Before the
FEDERAL COMMUNICATIONS COMMISSION

MM Docket No. 96-10

RM-8738

REPLY COMMENTS

STATIONS IN KGRI LOSS AREA STUDY

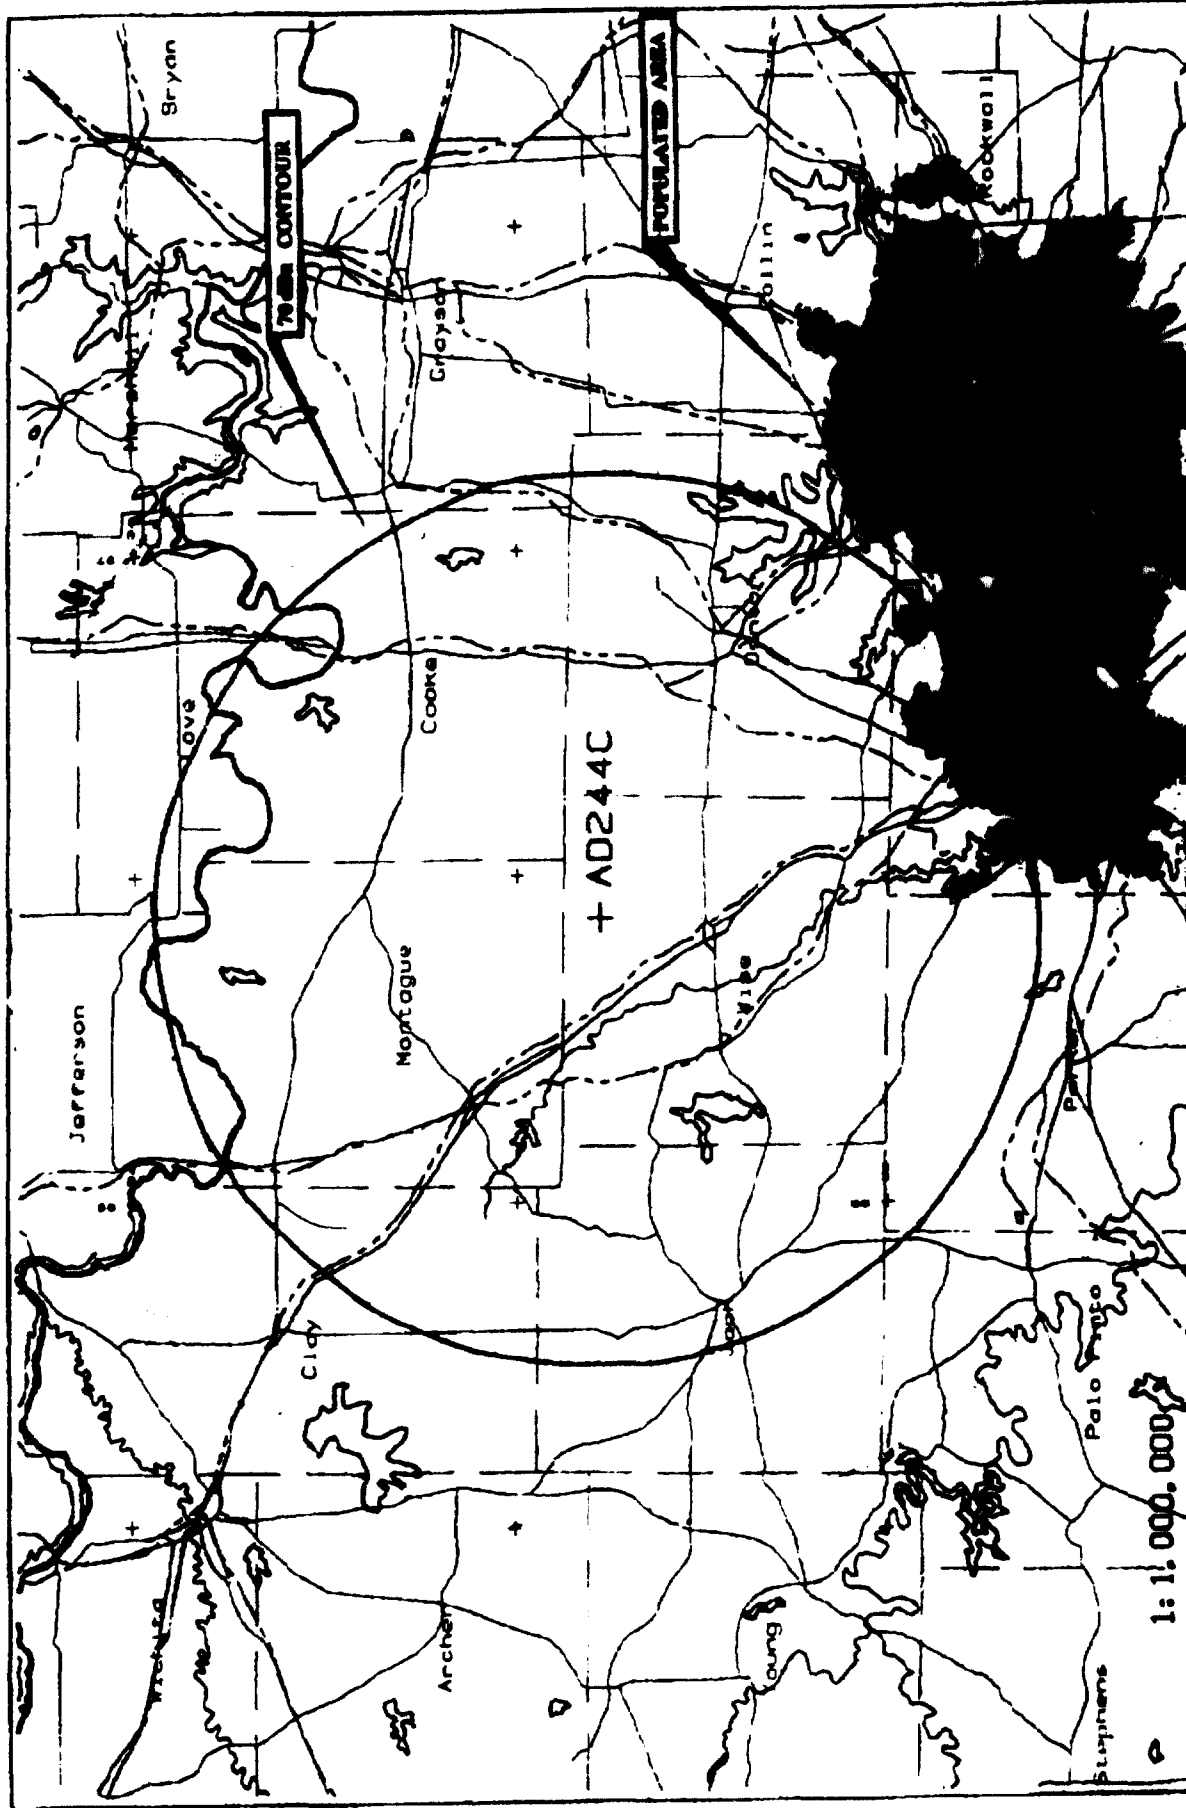
3. Third, at Exhibit E, Figure 15 of the Engineering Statement, the stations which provide service within the current KGRI 60 dBu contour area were depicted. For purposes of clarity and to supplement the showing, we have included an additional map which shades the loss area created by KGRI's proposed move. In addition, a listing of the stations which provide service to the loss area is included. See Exhibit 3. The listing indicates that three stations cover all of the loss area, and the remaining seven stations cover portions of the loss area. As a result and as stated in the Joint Counterproposal, every portion of the loss area will continue to receive at least five aural services.

Exhibit E, Figure 15 is a computer generated map of the present and proposed KGRI(FM) 60 dBu service. In addition, the AM and FM service contours (60 dBu FM and 2 mV/m AM) were shown. A revised Exhibit E, Figure 15 is included with

a tabular listing of all stations included and their contribution to the required 5 remaining primary service contours. The KGRI loss area is shaded for clarity.
